Re: Application for Permit 37-22685 Ground water heat pump and injection

HAGEY RESIDENCE - SHALLOW INJECTION WELL

Date: February 23, 2012
To: Allen Merritt
From: Michele Edl
Re: Hagey application review

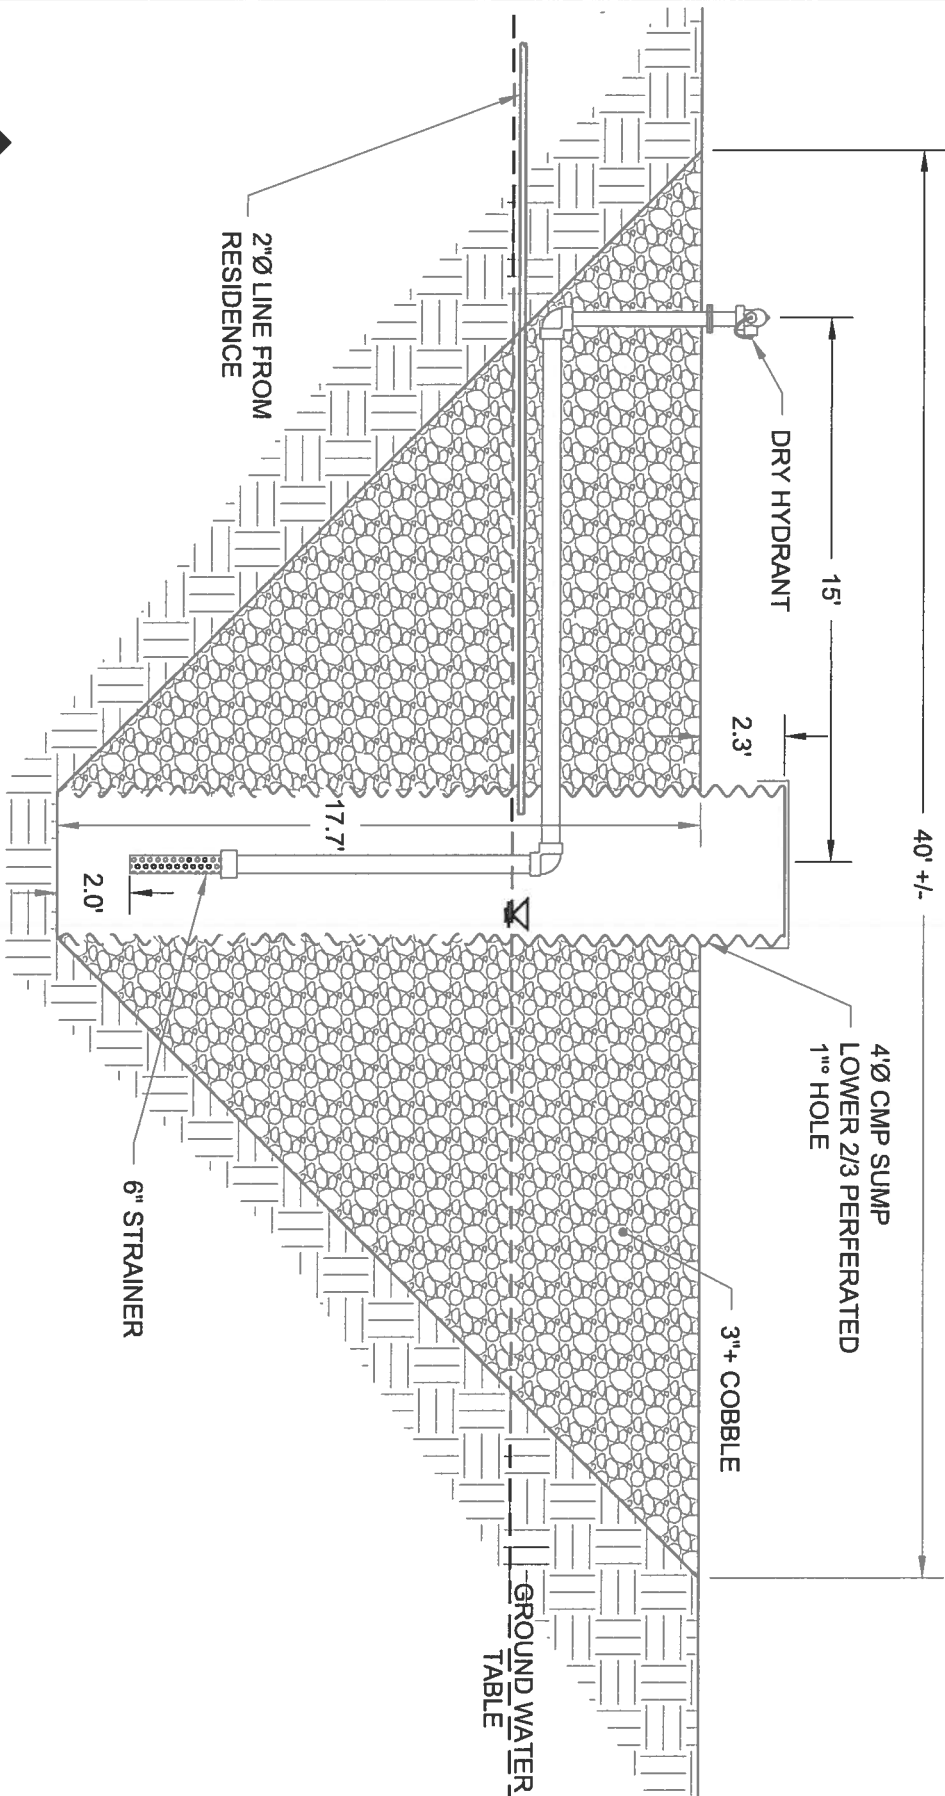
This type of failure will expose ground water to surface conditions and consumptive use. Without a demonstrated understanding of the sumps capacity to accept discharge expected from the heating/cooling system, the applicants run the real risk of installing a system that puts them out of compliance with constraints of the ground water management area.

Heat pumps cannot supply all the heat required by building at outside temperatures below the balance point. A heat pump system in the Hailey/Ketchum climatic region will likely require a supplemental heat source. The applicant should expect to use a supplemental heat system as the primary heat system if/when the injection sump reaches its capacity to accept heating system discharge and becomes a consumptive surface water feature.

The effluent injection sump serves to convey the requested 71.8 gpm maximum flow into the shallow aquifer and the sump also serves as the source for water for fire protection, as approved by the Wood River Fire District. I am enclosing a drawing of the proposed heating system disposal and fire protection sump.

- The hydraulic capacity of the re-injection system utilizing the proposed, perforated, 4.0 ft diameter CMP is more than adequate for the 71.8 gpm maximum effluent discharge. The depth to water at the sump has been measured at 5.2 ft below ground level. The estimated seepage area including the 4.0 ft diameter bottom of the CMP plus the clean cobble is approximately 1009 sq feet. The Theiss equation for a partially penetrating well (Bradbury and Rothschild (1985) specific capacity method and Sternburg (1973) partial penetration approach) in very permeable gravel (300 ft/day) shows that, with a conservative surcharge of 2 ft of head on the ground water level, the calculated capacity of the system is 0.22 cfs or 100 gpm. The water level in the CMP could operate at higher than a 2.0 ft surcharge which will increase the calculated infiltration capacity which is nearly linearly with the surcharge level.
